[REDACTED]
Subject: 2022/0157/PPP Flood Risk Assessment

2022/0157/PPP RESPONSE TO FLOOD RISK ASSESSMENT

Woodbank House/Old Luss Road Area

Figure 5

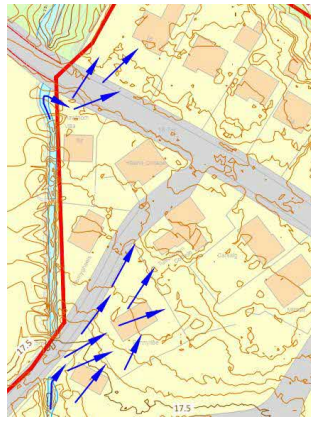
Flood Risk Assessment at Site E Woodbank Site from the Unnamed Watercourse 2 (UW2) dated 10 Dec 2018 (Fig5 below) shows overtopping of Unnamed Watercourse 2 flowing into residential properties.

Figure 6 SEPA Flood Map

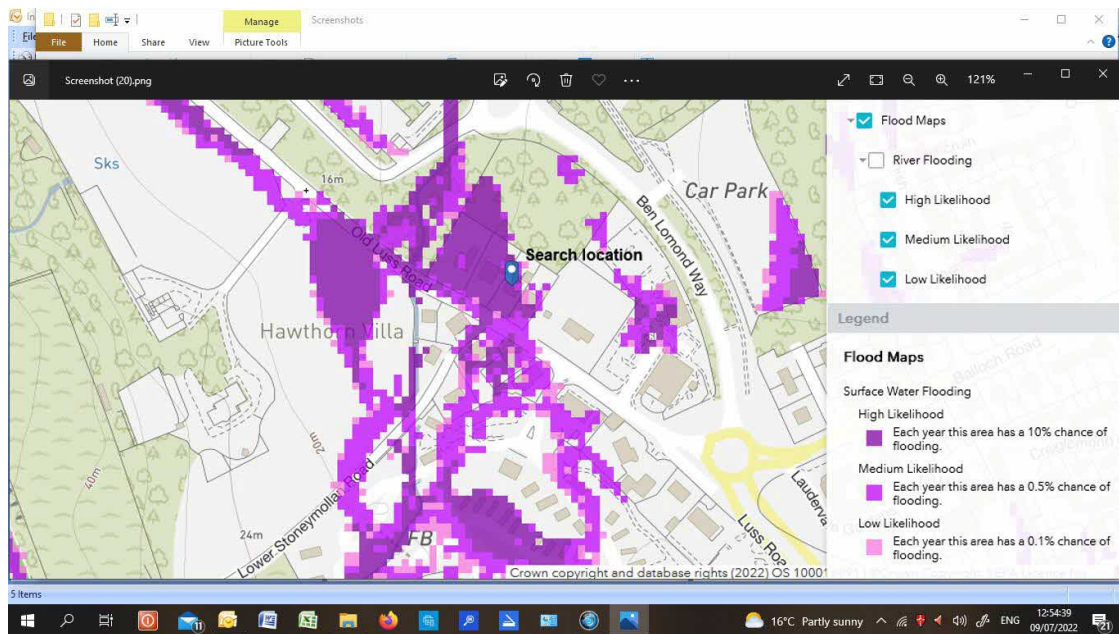
Note: This is consistent with the SEPA flood map in Fig6 below which highlights a 10% risk of flooding for properties in Old Luss Road and Lower Stoneymollen Road.
